SBK-L-09206

Seabrook Station  
Regulatory Conference Information

REGULATORY CONFERENCE – DGB SDP  
Questions from Chris Cahill (and Larry Scholl & Dan Orr), NRC Region 1  
September 11, 2009

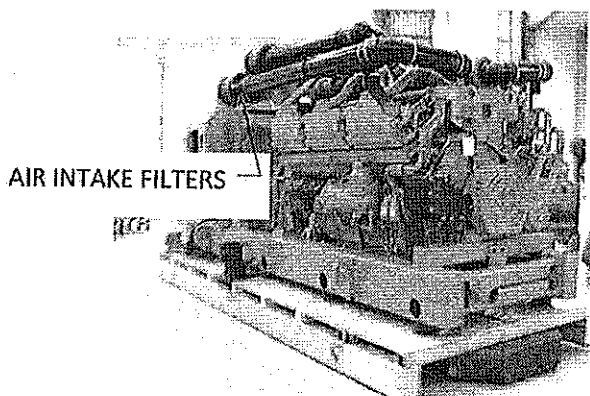
1. In an early letter from Cummins, the vendor did not support the conclusions of your Electrical Analysis. What was the basis for Cummins to revise the letter sent to you in response to your July 28, 2009 letter? Provide any additional vendor documentation to support the 1-of-2 SEPS success criteria.

*Response: The vendor letter was received on 08/04/09 and was based on a qualitative analysis. After the vendor was requested to provide the response of the genset under overloaded conditions factory testing results were provided by Cummins on 08/28/09. These test results indicated a different behavior that showed improved genset response. See Figure 1.*

AIR INTAKE FILTERS

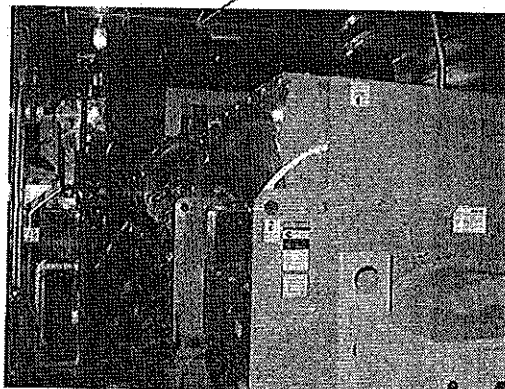
2. The Engineering Evaluation (Rev 2) page 9 credits additional SEPS power based on break-in. How were potential derating factors - such as fuel density/energy/restrictions and air restrictions identified in Cummins letter – dealt with?

*Response: If the on-site fuel density is higher than the fuel used during factory testing an increase in power of 1% can be expected. Conversely, if the on-site fuel density is less then a decrease in power can be expected. The factory fuel density is equivalent to the fuel density of the SEPS procured fuel and no reduction or increase in power output is needed.*

*If the air flow during factory testing was greater than the air flow for the as installed gensets then a reduction in power output would be expected. Conversely, if the air flow during factory testing was restricted more than the air flow for the as installed gensets an increase in power output would be expected. The gensets used the same air filters during testing as the installed units. At the factory test the test cell air intake used building air as the supply. The as installed gensets have a more direct outdoor air supply. Although the as installed gensets have a more direct supply of outdoor air the evaluation considers the air intake to be equivalent and a power reduction or increase does not need to be used.*
